ADDENDUM NO. 001

Architects Project No.: 23042

Project Name: Ralston Apartment Renovations

1 ARCHITECTURAL SITE PLAN
A001 1/8" = 1'-0"

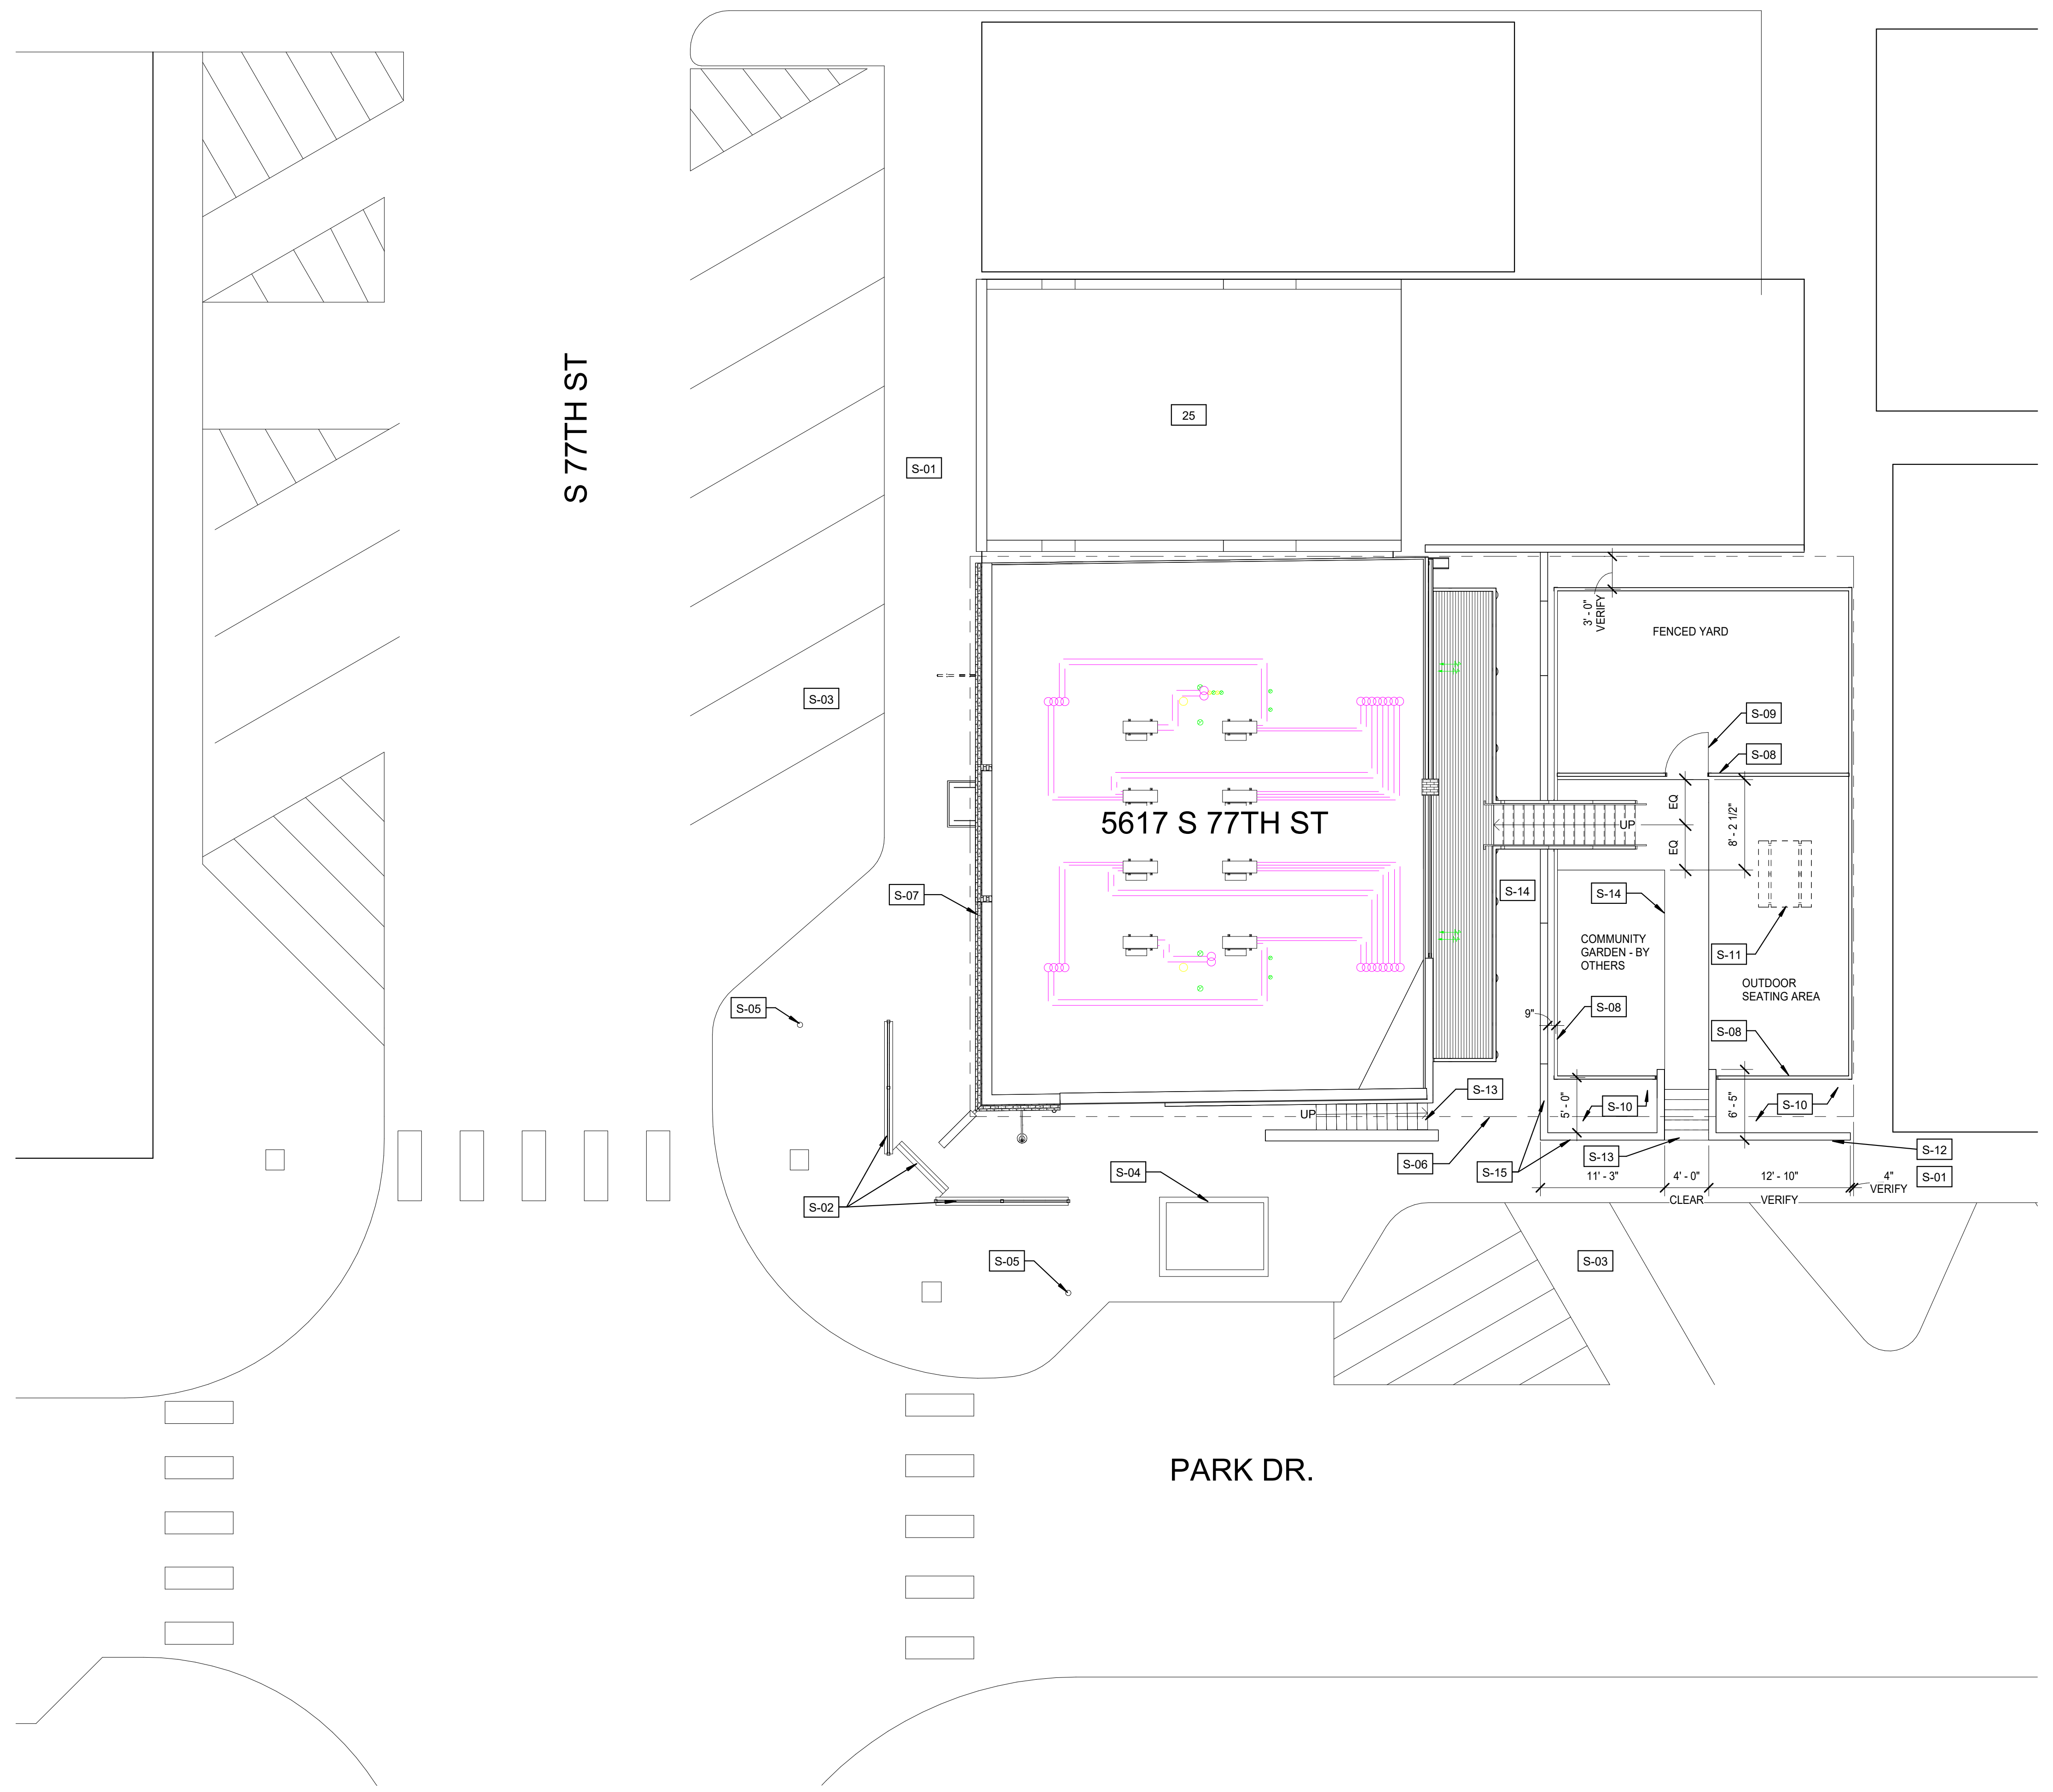
2. What is the basis of design for the fence?
 - a. See revised sheet A001 ARCH SITE PLAN in Addendum 1.
3. Any asbestos abatement required?
 - a. None anticipated, stop work and report to architect immediately if discovered.

1. Sheet - A001 ARCH SITE PLAN
 - a. Added basis of design for exterior fence and gate in response to RFI-01.
2. Sheet - A202 FLOOR PLANS, WALL TYPES, DOOR AND WINDOW SCHEDULES

FLOOR PLANS, WALL TYPES, DOOR AND WINDOW SCHEDULES

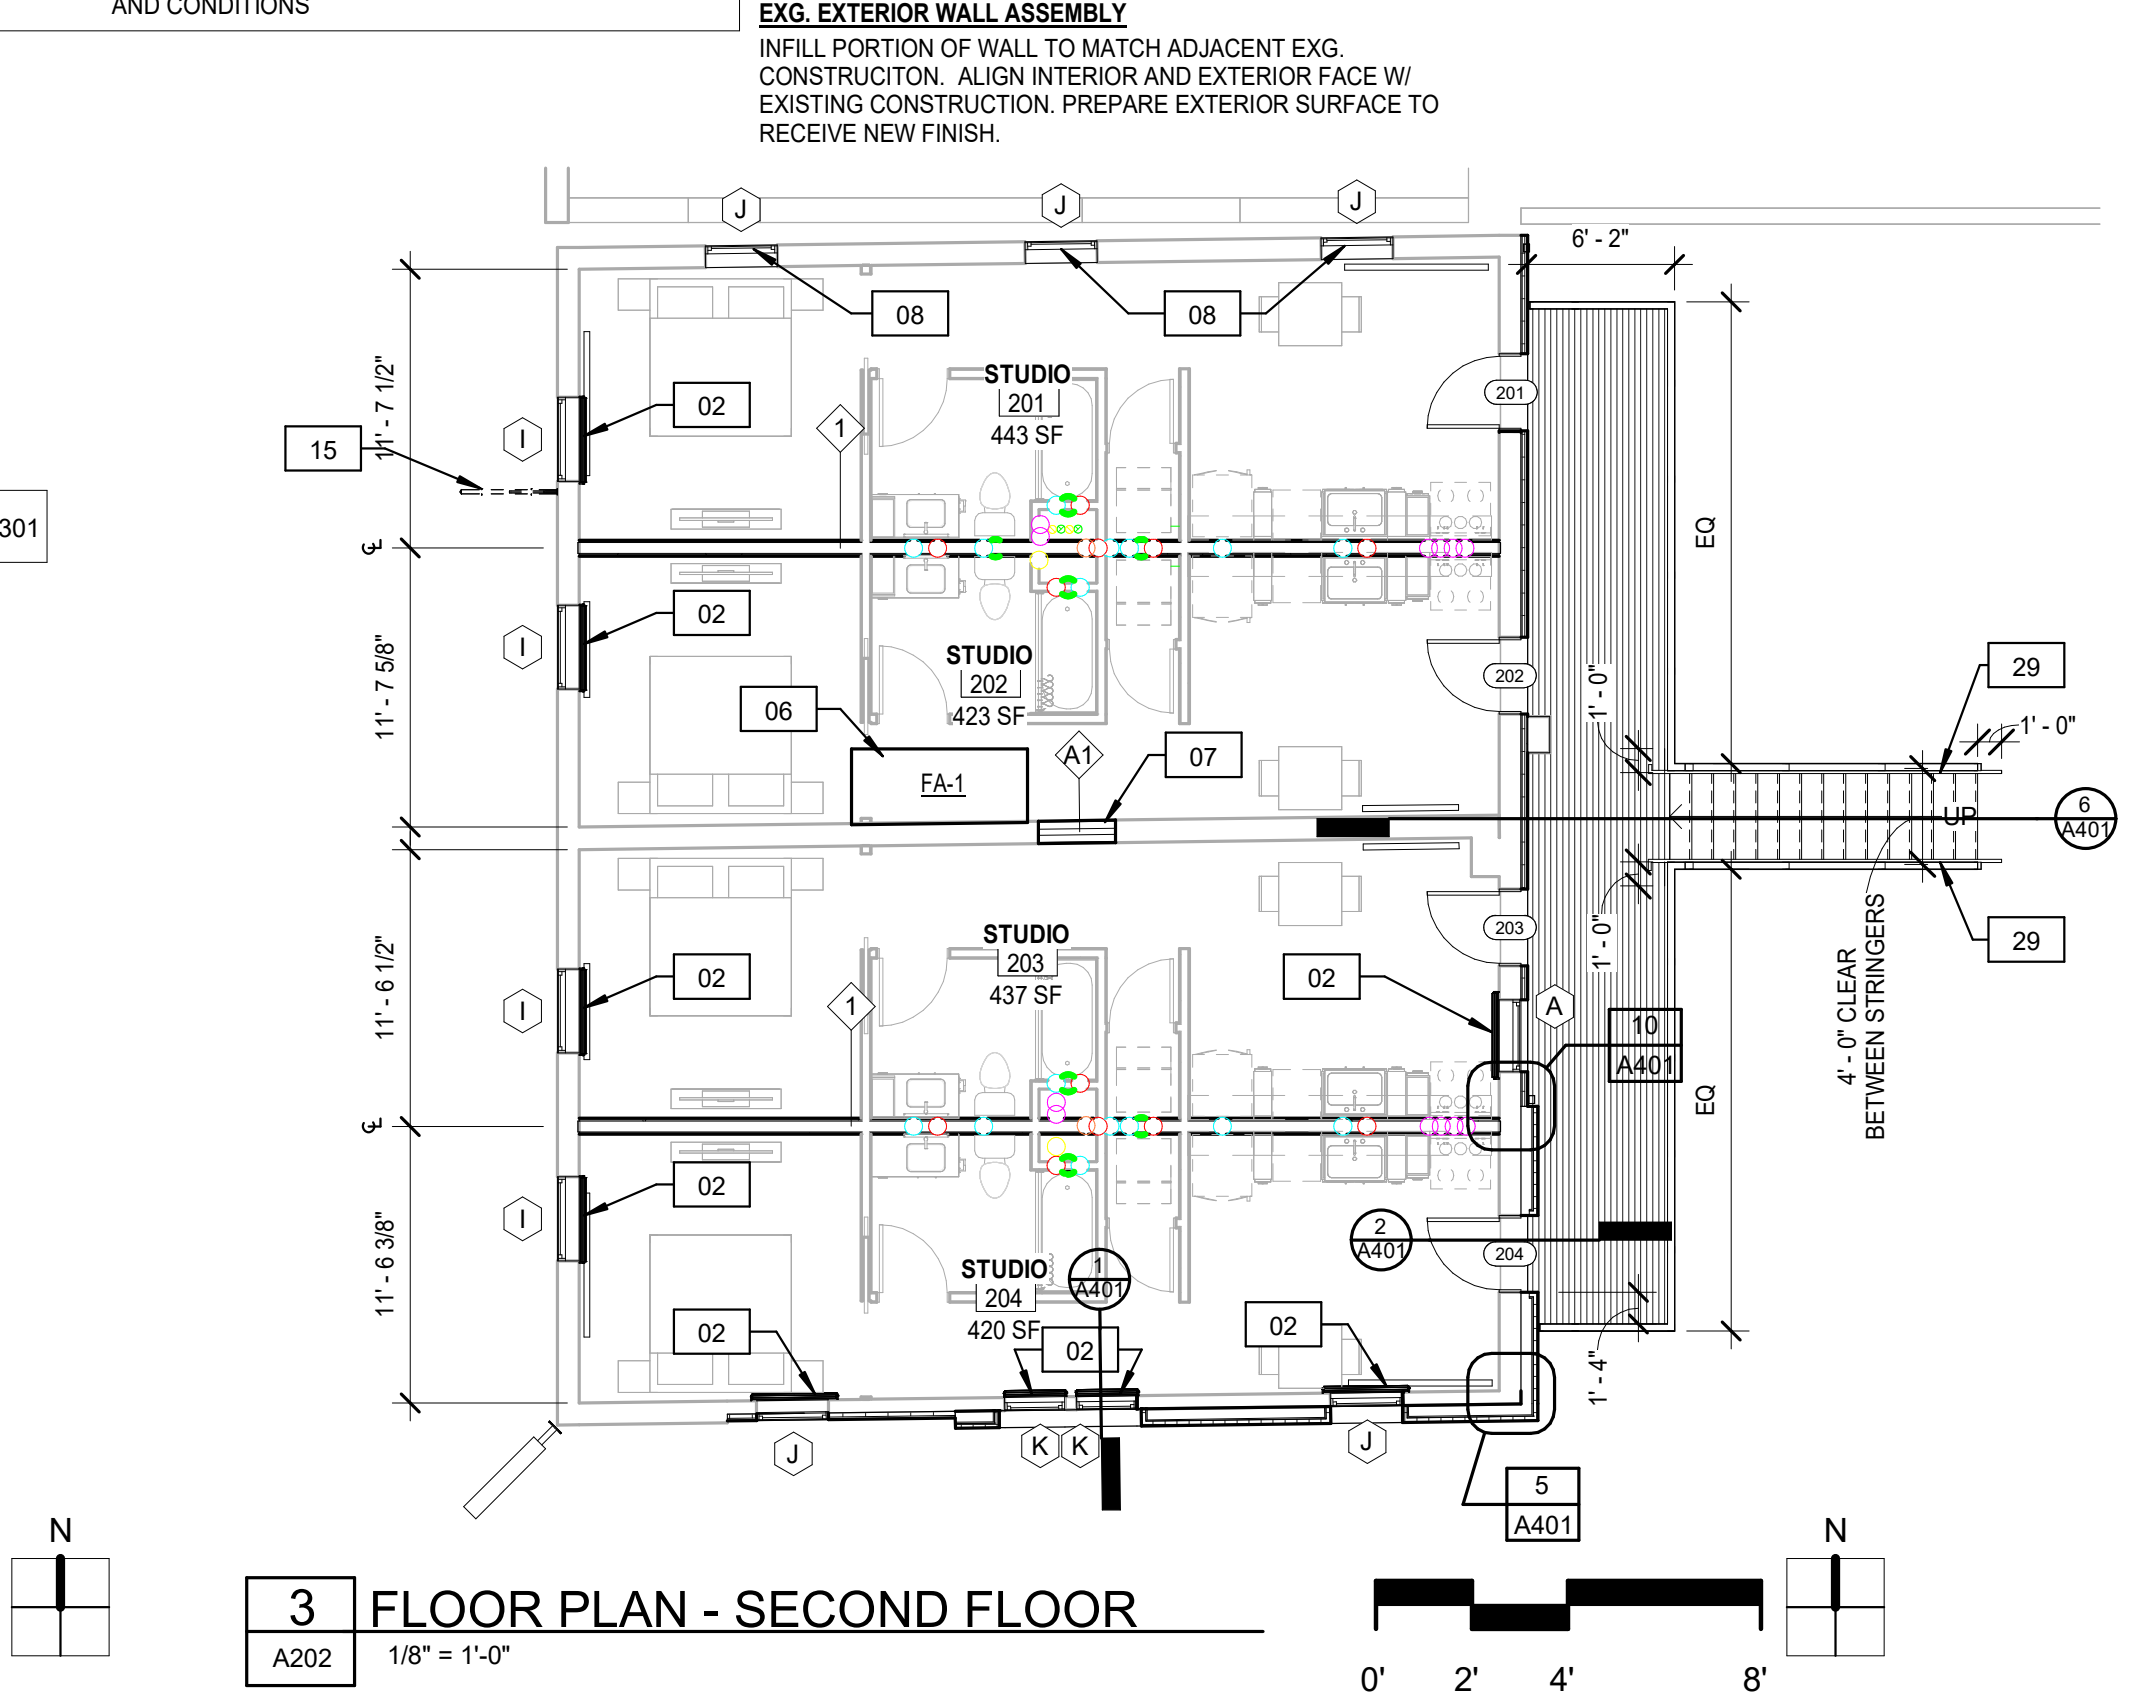
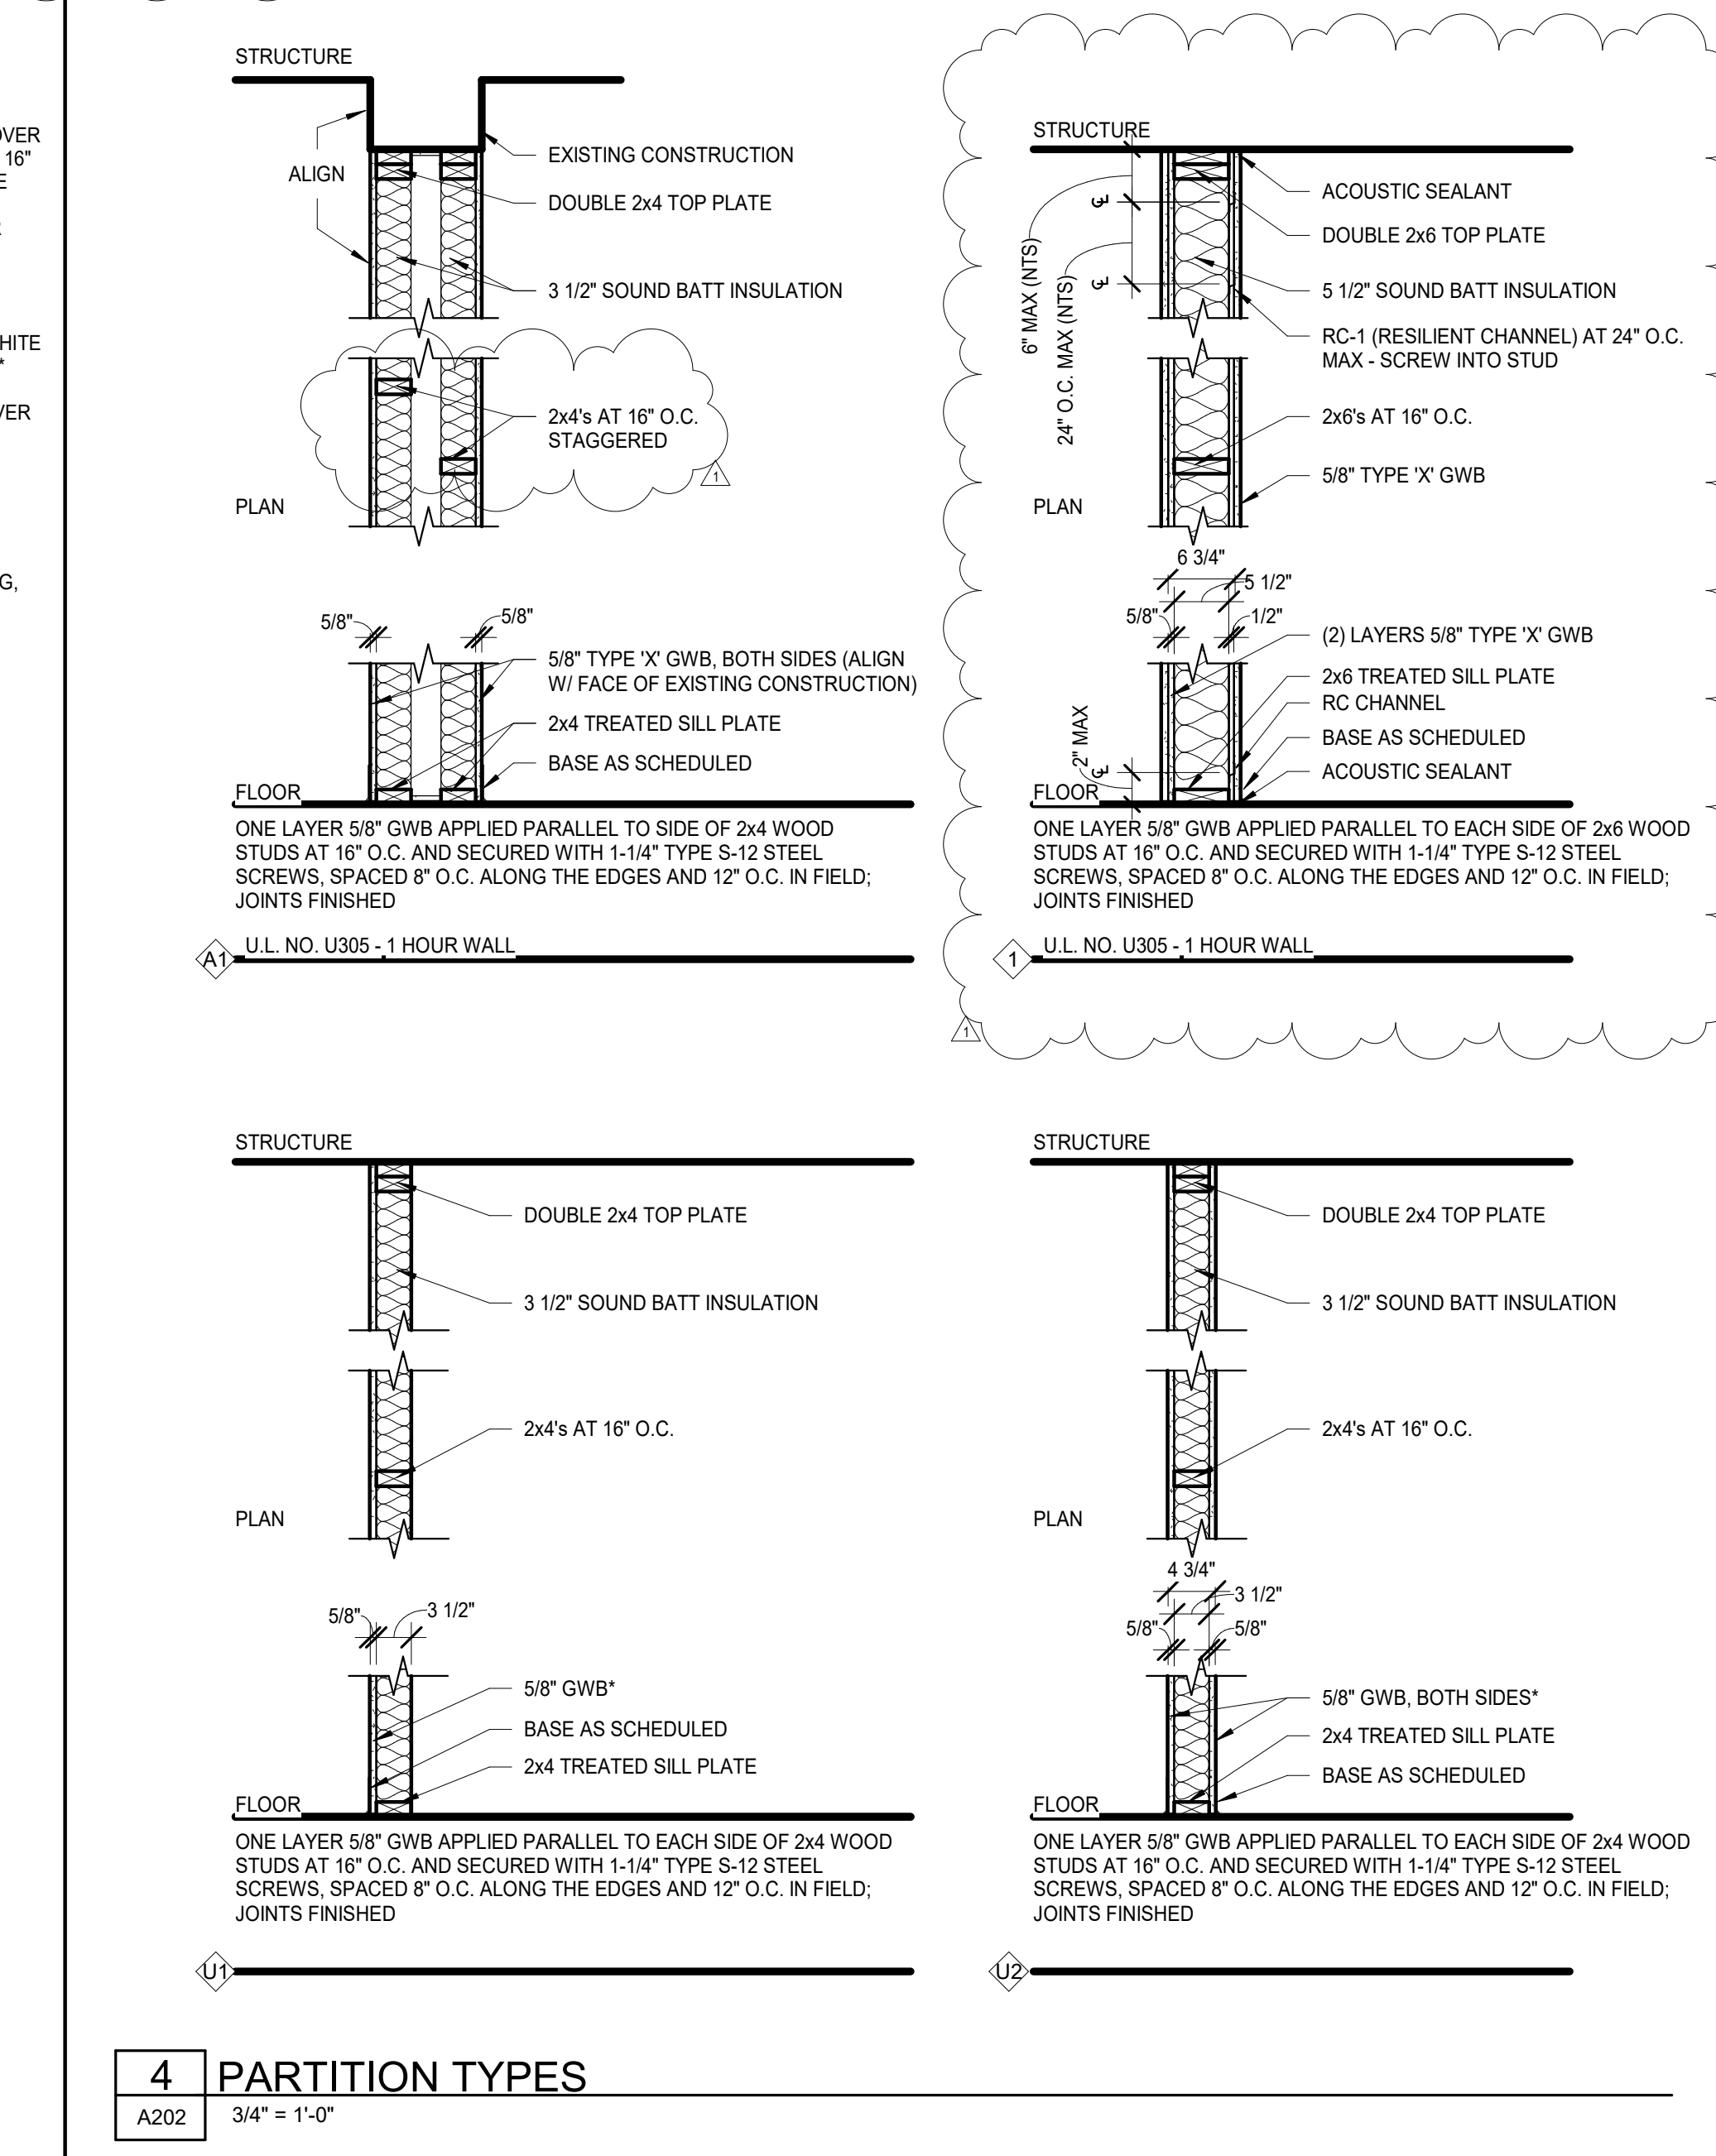
- a. See revised sheet A202 FLOOR PLANS, WALL TYPES, DOOR AND WINDOW SCHEDULES in Addendum 1
6. What thickness of Corian countertops are you looking for?

- a. Added basis of design and size information to windows in response to RFI-01.
 - b. Added resilient channels to walltype 1 and removed a layer of GWB.

- c. Showing hardware sets.
 - d. Specified paint color for doors and frames where indicated.
 - e. Staggered studs at walltype A1.
3. Sheet - A203 UNIT PLANS
